City of Sugar Hill  
Planning Staff Report  
**TCO Design Review 21-002**

**DATE:** July 29, 2021  
**TO:** Mayor and Council, Design Review Board  
**FROM:** Planning Director  
**SUBJECT:** Town Center Overlay District (TCO) design review  
Medical office, Sycamore Road at Nelson Brogdon Boulevard

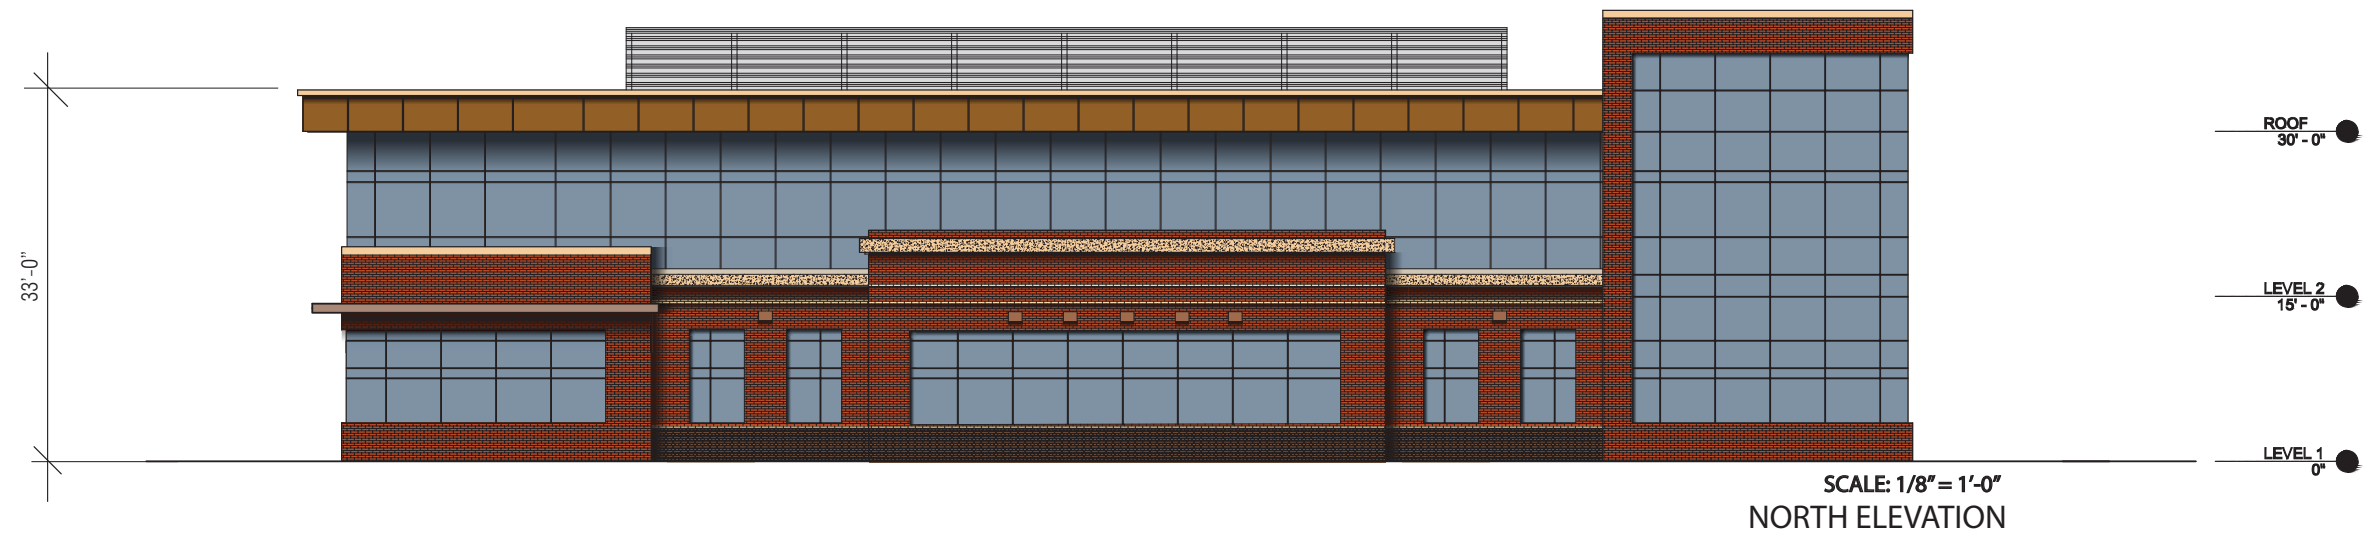
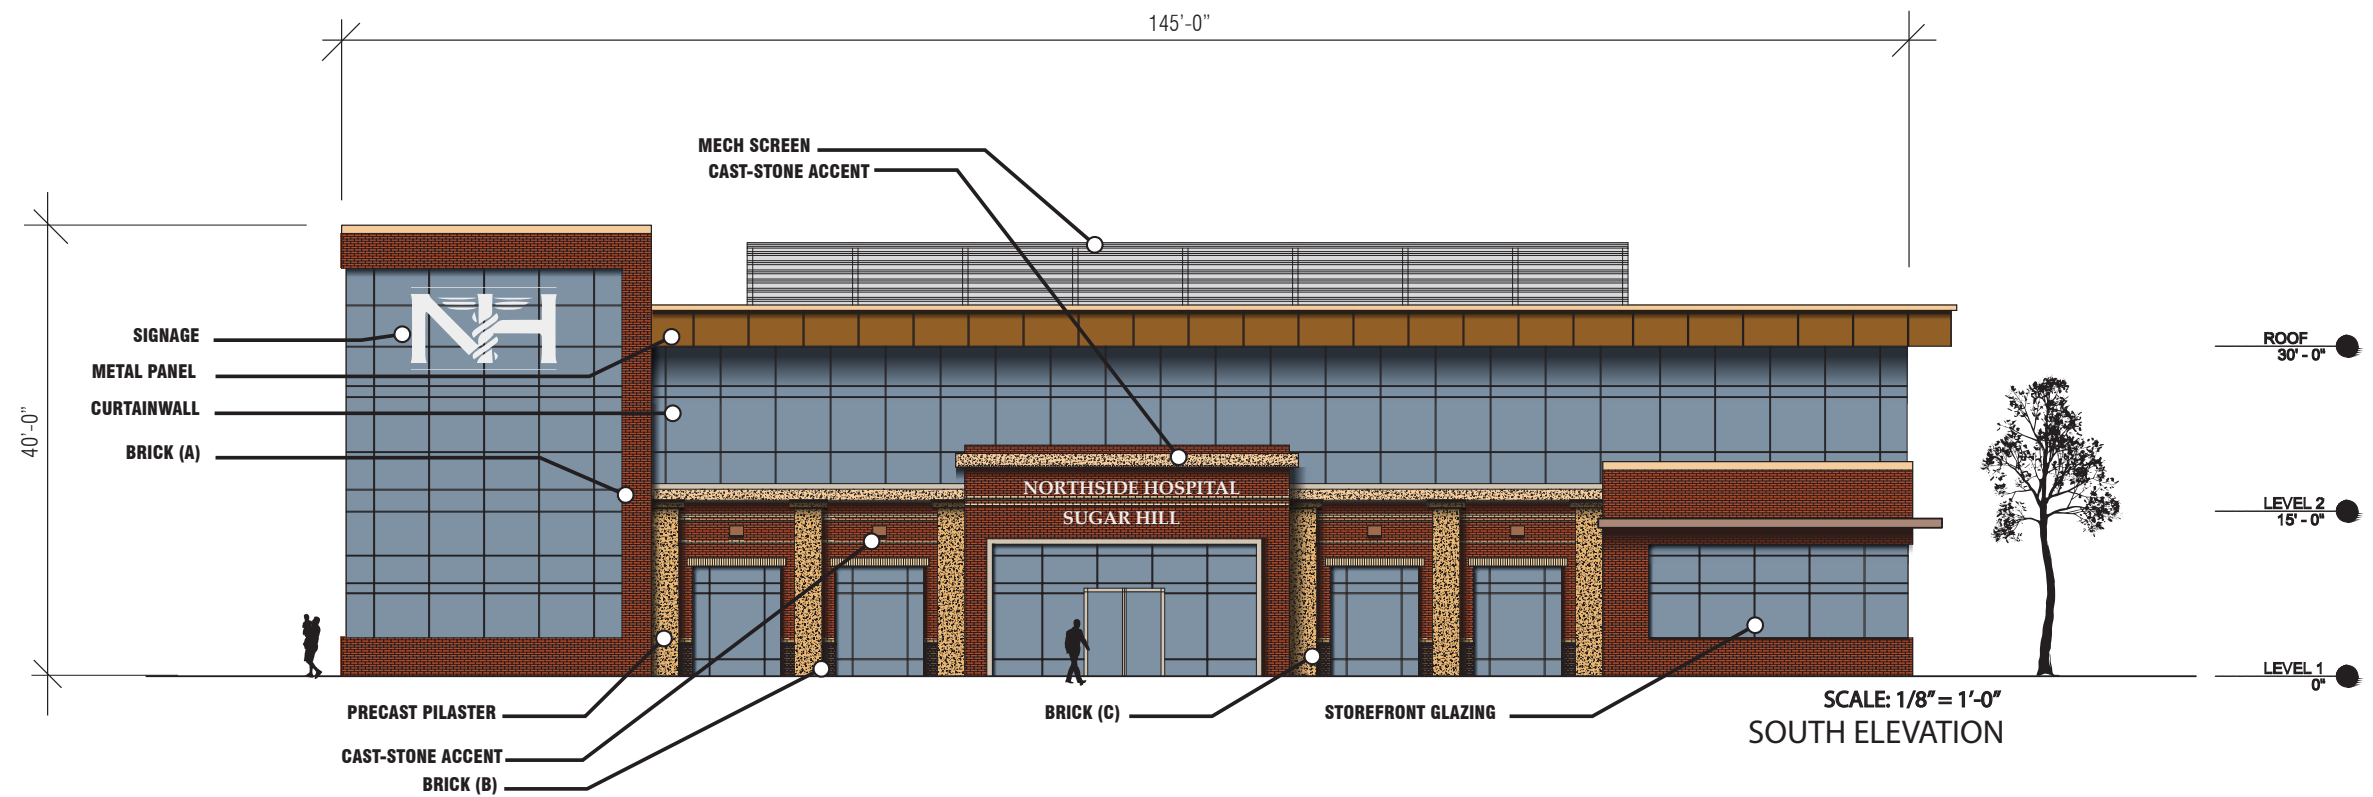
6. Dumpster enclosure shall be constructed of materials to match the principal building.
